TE Connectivity

Product Change Notification: E-17-011618

General Product Description:
AMPMODU 50-50 GRID HEADER AND RECEPTACLE PRODUCT WITH VACUUM COVERS

50/50 Grid Receptacle Vacuum Cap Change

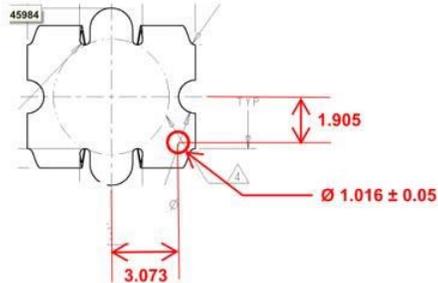
Description of Changes
ADDING HOLE TO COVER TO ALLOW VISION SYSTEM TO CHECK ORIENTATION OF PART IN POCKET TAPE.

RECEPTACLE CAP CHANGE

Reason for Changes:	
Product Improvement. THE ONLY CHANGE IS TO THE VACUUM COVER. THERE IS NO CHANGE TO THE CONNECTOR.-ADDING A CUT OUT SECTION TO THE TOP SURFACE OF THE CAP TO ALLOW A VISION SYSTEM TO SENSE WHETHER OR NOT THE PART IS ORIENTED CORRECTLY IN THE POCKET TAPE.-AGAIN THE ONLY CHANGE IS TO THE CAP. NOTHING CHANGES ON THE CONNECTOR.	
Estimated Dates:	
Last Order Date (Obsolete Parts Only):	First Date To Ship (Changed Parts Only):
	15-DEC-2017
Last Ship Date (Obsolete Parts Only):	Last Date for Mixed Shipments: (Changed Parts Only):
	No Mixed Shipments
